# City Council Planning Department Staff Report

Planning and Zoning  
Commission Meeting: April 7, 2026  
Project No: VAR2026-002  
Project Planner: Sara Varvarigos, AICP, Senior Planner

**Project Name:** N/A  
**Property Location:** 613 Hazy Hills Loop  
**Legal Description:** Headwaters at Barton Creek Phase 1, Block B, Lot 27, Acres 0.2009 (8,752 SF)  
**Applicant:** Carlos Castillo  
**Property Owner:** Cory King  
**Request:** Applicant is requesting a variance to allow a pergola within the rear property setback and increase the maximum impervious cover permitted on site  
**Recommendation:** Staff recommends **denial** of the variance request.

## PLOT PLAN

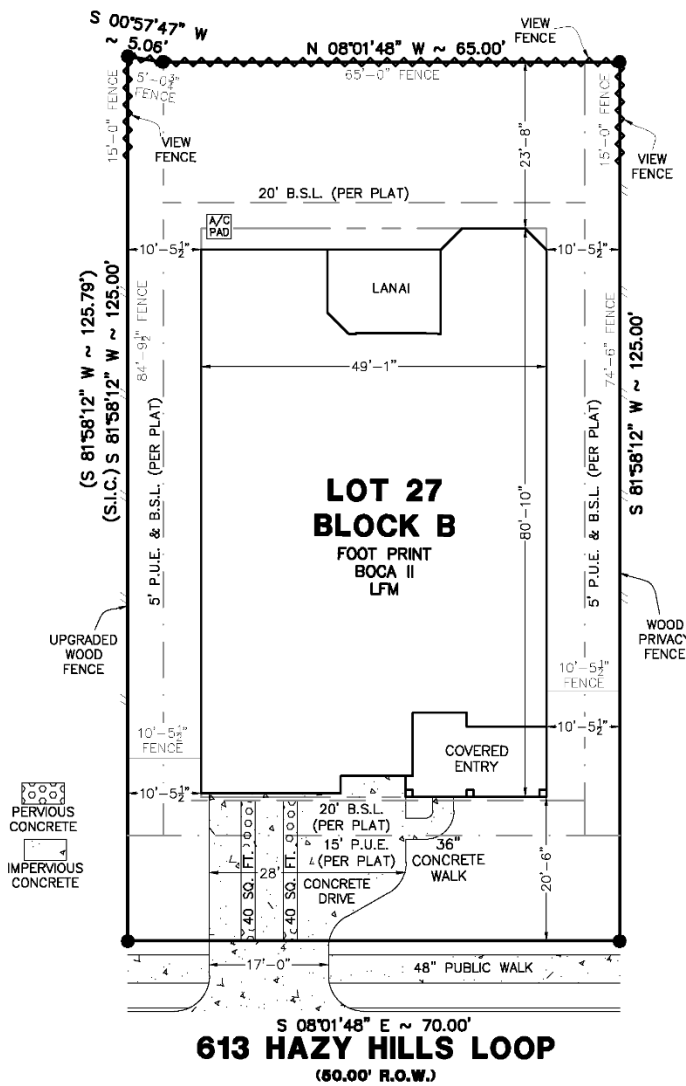
This variance request is associated with a requested building permit for a cantilevered pergola at 613 Hazy Hills Loop. This property is located in Phase 1 of the Headwaters subdivision. As such, it is subject to the Headwaters at Barton Creek Development Agreement and Phase 1 Plat development requirements. These documents establish a minimum rear yard setback of 20' and a side yard setback of 5', as well as a maximum impervious cover of 50% for all residential lots. The existing yard setbacks and impervious cover (49.5%) of 613 Hazy Hills Loop are shown in the Plot Plan below:

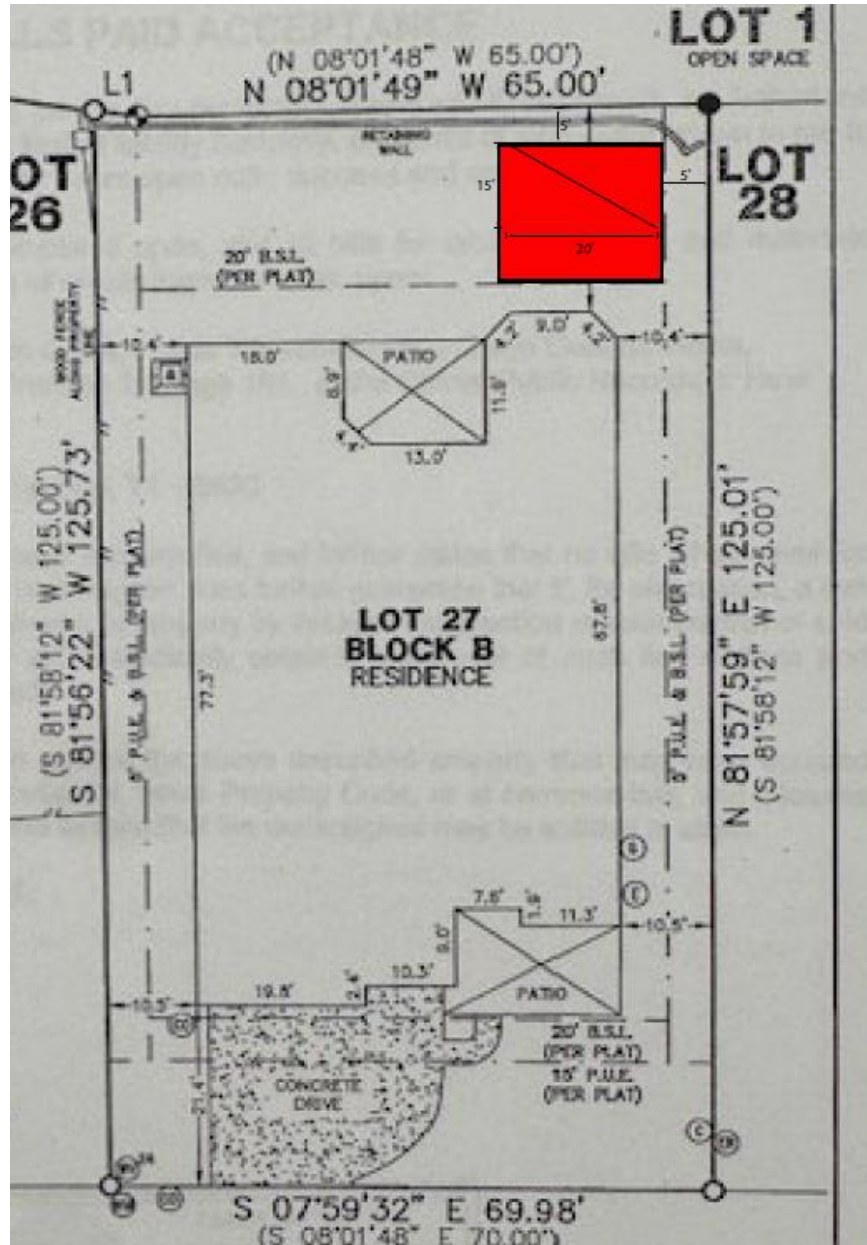
The applicant is proposing to add a 1-story pergola measuring 20' wide x 15' deep x 10' height (refer to Attachment 1), which would encroach 15' into the property's required 20' rear yard building setback, as shown in the proposed site plan exhibit below. It would also add approximately 300 SF of impervious cover to the 8,752 SF lot, increasing the impervious cover from 49.5% to 53%, which is over the maximum permitted impervious cover of 50% for residential lots. In the building permit application for the proposed pergola, the applicant indicated that the property's impervious cover after the project would be 30%, which is incorrect.

Summary of Site Plan Elements	Site Area (SF)	Impervious Cover
<b>Residential Lot</b>	<b>8,752</b>	<b>50% Max Imp. Cover</b>
Existing Slab	3,818	43.6%
Existing Flat Work	513	5.9%
<b>Total Existing Impervious Area</b>	<b>4,331</b>	<b>49.5% (Under 50% Max)</b>
Proposed Pergola Addition	300	3.4%
<b>Total Proposed Impervious Area</b>	<b>4,631</b>	<b>53% (Over 50% Max)</b>
